Bulletin No.: 14030A  
Date: April 2014

# Recall Bulletin

**SUBJECT:** Side Impact Airbag Connector

**MODELS:** Some 2008-2009 and all 2010-2013 Buick Enclave  
Some 2009 and all 2010-2013 Chevrolet Traverse  
Some 2008-2009 and all 2010-2013 GMC Acadia  
Some 2008-2009 and all 2010 Saturn OUTLOOK

3782976

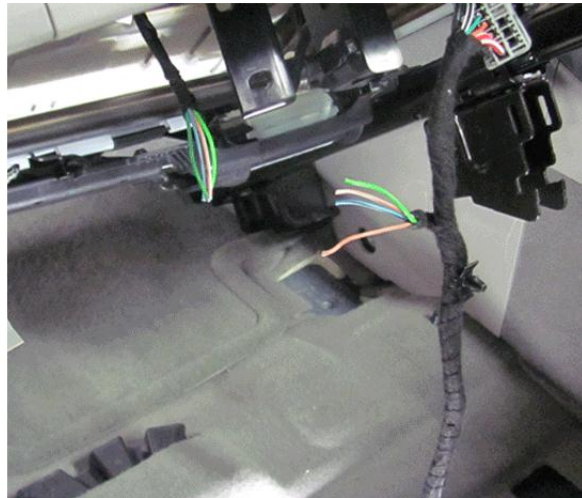
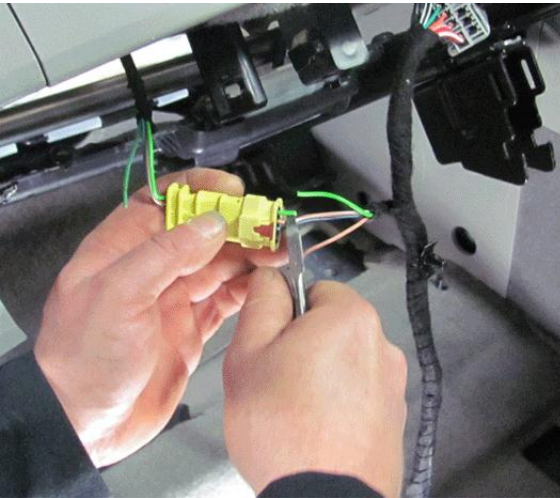
The service procedure in this bulletin has been revised. A revision has been made to the Note statement before Step 5, and a Note statement has been added before Step 10. Please discard all copies of bulletin 14030.

**Note:** Before removing the yellow connector from the seat and body harness, note the wire colors of the seat and body harness. Some wire pairs may be a slightly different color. Some wire pairs may have different colors. Ensure the wires are matched BEFORE splicing the wires of the seat and body harness together. Use the cutoff connector as a wire color template. BEFORE removing the connector from the harness, mark or identify wire pairs of similar color using a pen and tape to ensure the correct wires are spliced together. The first photograph shows a 4-way connector (1) and a 6-way connector (2).
